An
Coimisiún
Pleanála

FSC Report

ACP-324139-26

Construction of a seven-storey
residential development comprising
149 no. apartment units over a
basement car park
at
Blocks 7, 8 & 9 Jacobs Island, Mahon,
Cork.

Figure 5: HRR for ICEV and EV fire tests (including a 2MW burner contribution) [42]

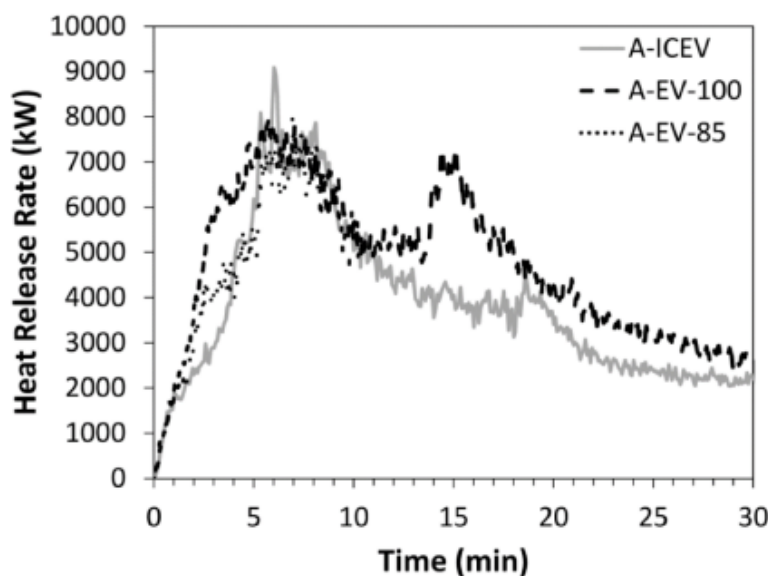
The BCA also refer to a report titled '*Covered car parks – fire safety guidance for electric vehicles*', Arup, 2023 to support their claim that thermal runaway fires are almost impossible to deal with from a firefighting perspective and will lead to more protracted incidents. This Arup paper compares full-scale fire tests between Internal Combustion Engine (ICE) and Electric Vehicles (EV) and concludes that although the heat release rate was found to be effectively the same the EV fire does tend to have two peaks (the second peak occurring when the battery becomes involved) as per Figure 5 (extract) below. The Arup report does acknowledge that fighting fires in EVs is 'different' but is more measured than the BCA's submission suggests in its coverage of firefighting measures, while still acknowledging the EV fires present real additional challenges.

The full-scale fire tests which have been undertaken to date [42] suggest that the overall fire size, in terms of heat release rate, are the same between EV and ICEV fires. Both have a peak size of approximately 8 MW, which includes a 2MW burner contribution [42].

The Arup report acknowledges that the duration of an EV fire is likely to be longer than their ICE counterparts (from 6 to 49 minutes for an EV, compared to 5 minutes for ICE). However the Arup report also notes that the frequency of EV fires is significantly lower than ICE cars as per Figure 7 (extract) below.

Whilst I acknowledge the BCAs point that, based on the Arup paper, EV fires in a basement car park may take longer to deal with than ICE fires there is no requirement under Regulation B5 to limit the timespan of fire service incidents. The Arup paper does itself provide recommended guidance and mitigation measures regarding EV fires in covered car parks.

The BCA’s caution regarding fires in modern vehicles is a legitimate concern, however, having considered the above I would agree with the Appellant on this point, there is no requirement in TGD-B to provide sprinklers under Regulation B5.

Figure 7: Illustration of likelihood of fire claims per car per year, sorted by propulsion type [10]

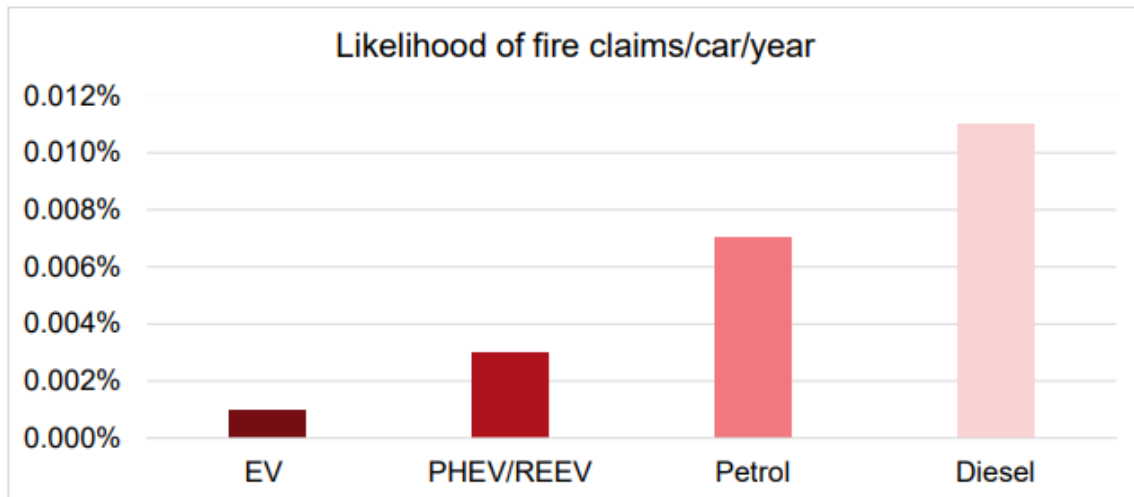
The Arup paper therefore paints a picture of longer duration EV fires but with a comparable peak HRR and occurring at a much reduced frequency. However, based on the Miechówka and Węgrzyński, 2025, paper discussed above this does not mean that EV fires are inherently more severe, since at the 95th and 99th percentiles the ICE fires were actually larger (as per Table 5 extract below).
